CITY PLAN COMMISSION

FILE NUMBER: Z212-271(JA) **DATE FILED:** May 25, 2022
LOCATION: Northeast corner of Linfield Road and Bonnie View Road
COUNCIL DISTRICT: 4
SIZE OF REQUEST: Approx. 10.19 acres **CENSUS TRACT:** 48113008703

REQUEST: An application for a Specific Use Permit for a public school other than an open-enrollment charter school on property zoned an R-5(A) Single Family District.

STAFF COMMENTS ON PROPOSED SUP SITE PLAN

PROPOSED SUP SITE PLAN

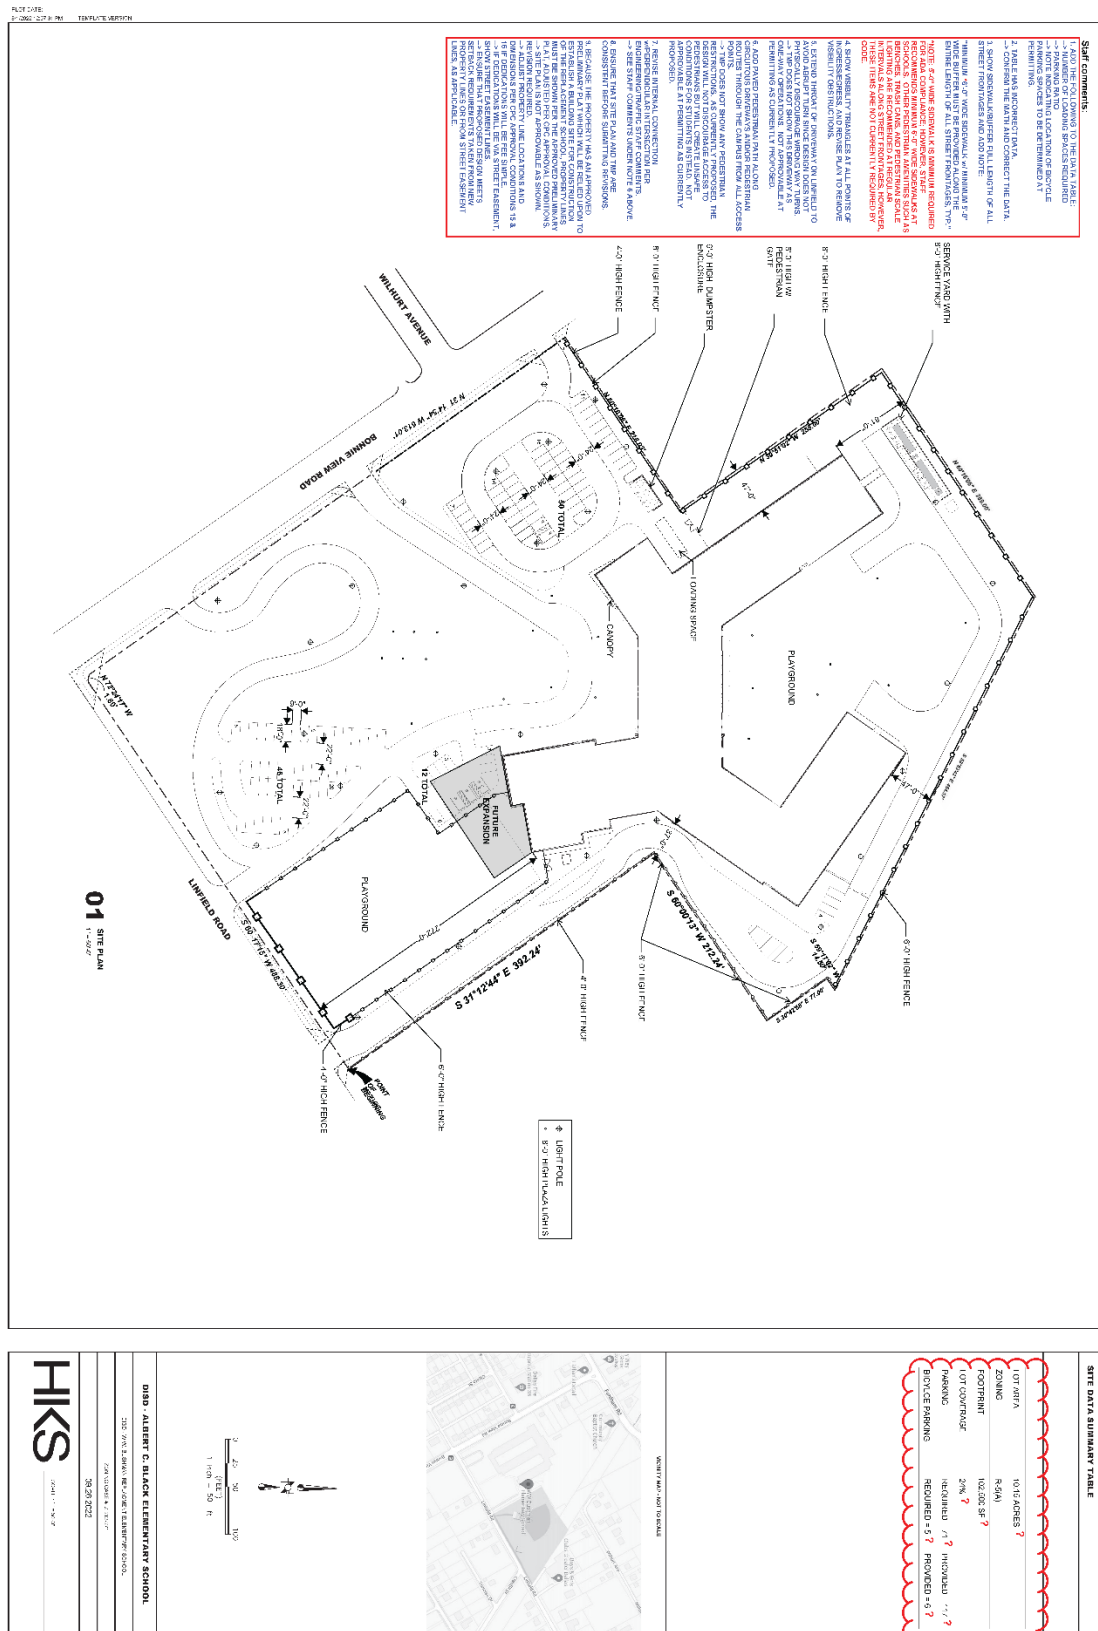
1. ADD THE FOLLOWING TO THE DATA TABLE:

--> NUMBER OF LOADING SPACES REQUIRED

--> PARKING RATIO

--> NOTE INDICATING LOCATION OF BICYCLE PARKING SPACES TO BE DETERMINED AT PERMITTING.

2. TABLE HAS INCORRECT DATA.

--> CONFIRM THE MATH AND CORRECT THE DATA.

3. SHOW SIDEWALK/BUFFER FULL LENGTH OF ALL STREET FRONTAGES AND ADD NOTE:

"MINIMUM *6'-0" WIDE SIDEWALK w/ MINIMUM 5'-0" WIDE BUFFER MUST BE PROVIDED ALONG THE ENTIRE LENGTH OF ALL STREET FRONTAGES, TYP."

***NOTE: 5'-0" WIDE SIDEWALK IS MINIMUM REQUIRED FOR ADA COMPLIANCE; HOWEVER, STAFF RECOMMENDS MINIMUM 6'-0" WIDE SIDEWALKS AT SCHOOLS. OTHER PEDESTRIAN AMENITIES SUCH AS BENCHES, TRASH CANS, AND PEDESTRIAN SCALE LIGHTING ARE RECOMMENDED AT REGULAR INTERVALS ALONG STREET FRONTAGES, HOWEVER, THESE ITEMS ARE NOT CURRENTLY REQUIRED BY CODE.**

4. SHOW VISIBILITY TRIANGLES AT ALL POINTS OF INGRESS/EGRESS, AND REVISE PLAN TO REMOVE VISIBILITY OBSTRUCTIONS.

5. EXTEND THROAT OF DRIVEWAY ON LINFIELD TO AVOID ABRUPT TURN SINCE DESIGN DOES NOT PHYSICALLY DISCOURAGE WRONG WAY TURNS.

--> TMP DOES NOT SHOW THIS DRIVEWAY AS ONE-WAY OPERATIONS. NOT APPROVABLE AT PERMITTING AS CURRENTLY PROPOSED.

6. ADD PAVED PEDESTRIAN PATH ALONG CIRCUITOUS DRIVEWAYS AND/OR PEDESTRIAN ROUTES THROUGH THE CAMPUS FROM ALL ACCESS POINTS.

--> TMP DOES NOT SHOW ANY PEDESTRIAN RESTRICTIONS. AS CURRENTLY PROPOSED, THE DESIGN WILL NOT DISCOURAGE ACCESS TO PEDESTRIANS BUT WILL CREATE UNSAFE CONDITIONS FOR STUDENTS INSTEAD. NOT APPROVABLE AT PERMITTING AS CURRENTLY PROPOSED.

7. REVISE INTERNAL CONNECTION w/PERPENDICULAR INTERSECTION PER ENGINEERING/TRAFFIC STAFF COMMENTS.

--> SEE STAFF COMMENTS UNDER NOTE 6 ABOVE.

8. ENSURE THAT SITE PLAN AND TMP ARE CONSISTENT BEFORE SUBMITTING REVISIONS.

9. BECAUSE THE PROPERTY HAS AN APPROVED PRELIMINARY PLAT WHICH WILL BE RELIED UPON TO ESTABLISH A BUILDING SITE FOR CONSTRUCTION OF THE REPLACEMENT SCHOOL, PROPERTY LINES MUST BE SHOWN PER THE APPROVED PRELIMINARY PLAT, ADJUSTED PER CPC APPROVAL CONDITIONS. --> SITE PLAN IS NOT APPROVABLE AS SHOWN. REVISION REQUIRED.

--> ADJUST PROPERTY LINE LOCATIONS AND DIMENSIONS PER CPC APPROVAL CONDITIONS 15 & 16 IF DEDICATIONS WILL BE FEE SIMPLE.

--> IF DEDICATIONS WILL BE VIA STREET EASEMENT, SHOW STREET EASEMENT LINES.

--> ENSURE THAT PROPOSED DESIGN MEETS SETBACK REQUIREMENTS TAKEN FROM NEW PROPERTY LINES OR FROM STREET EASEMENT LINES, AS APPLICABLE.

The TMP recommendations are described below and shown in **Exhibit 1**.

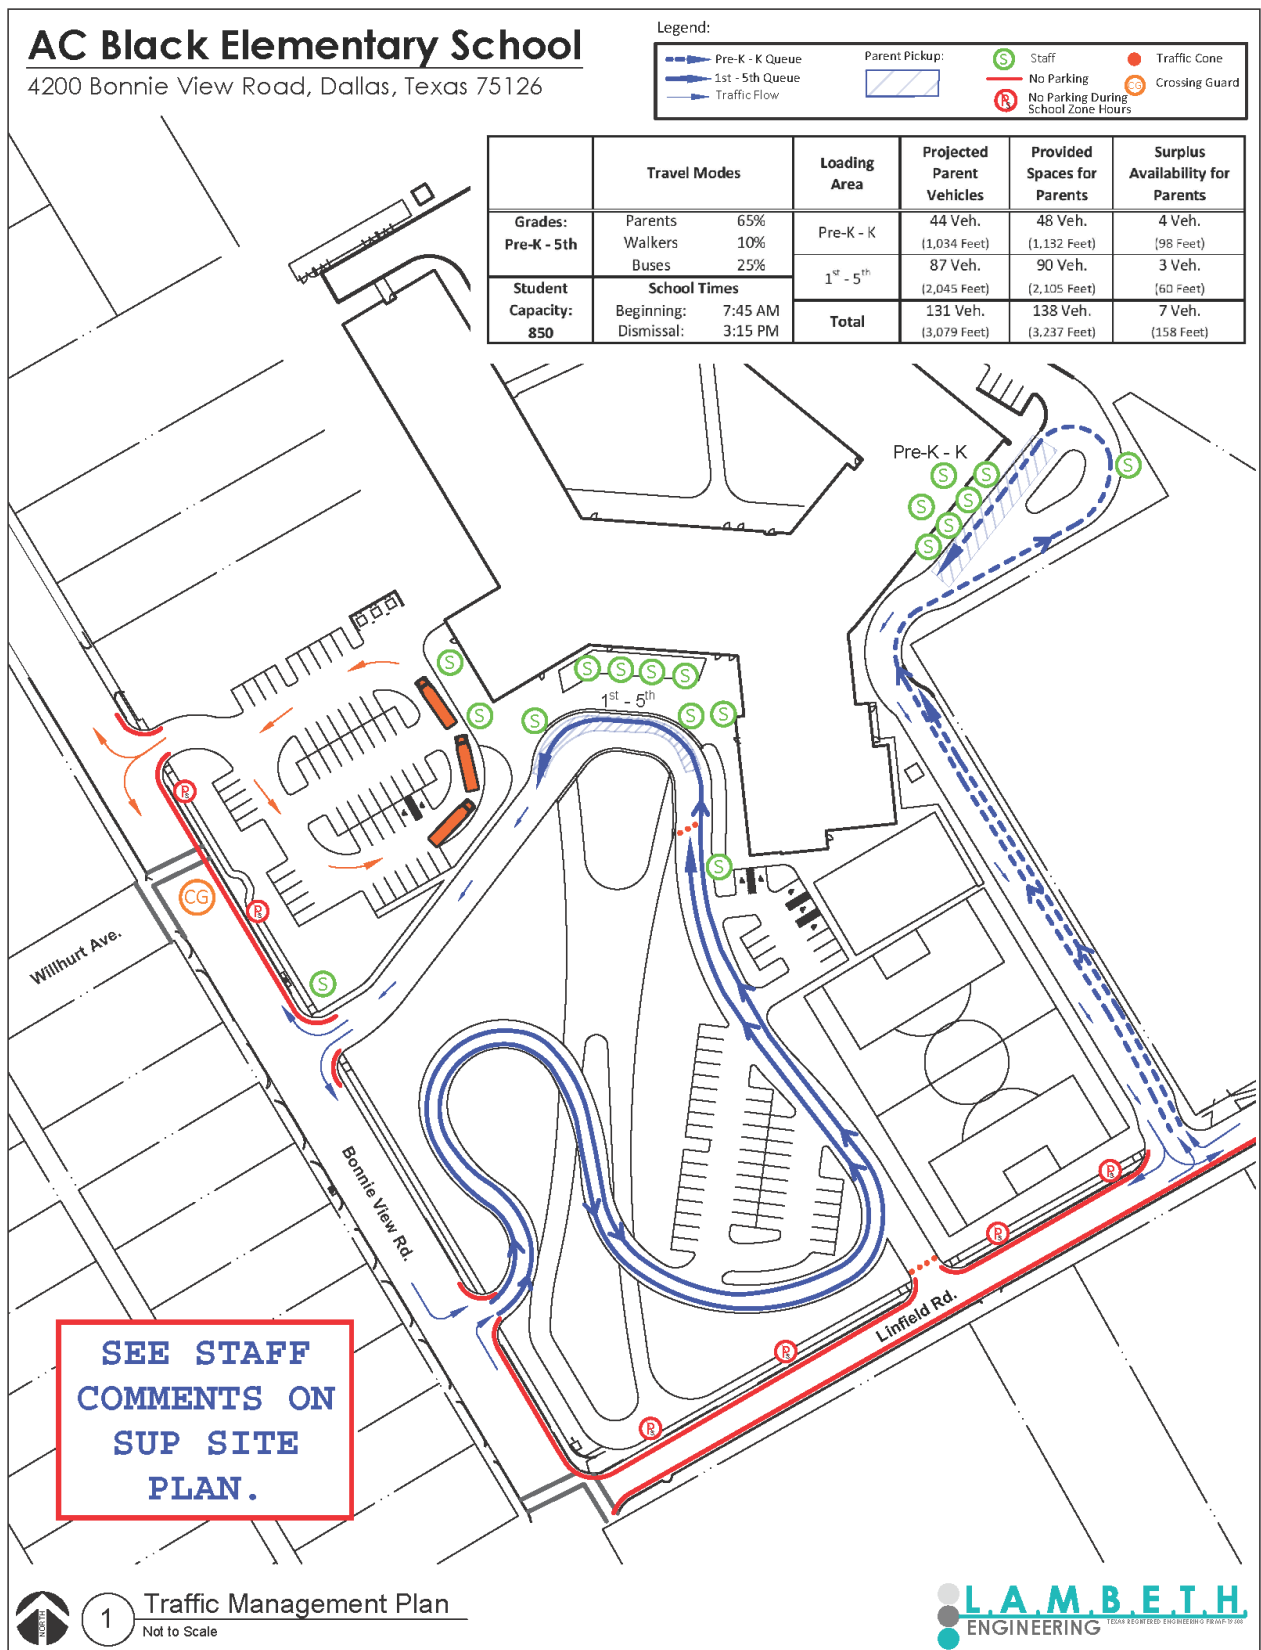
**SEE STAFF
COMMENTS ON
SUP SITE
PLAN.**
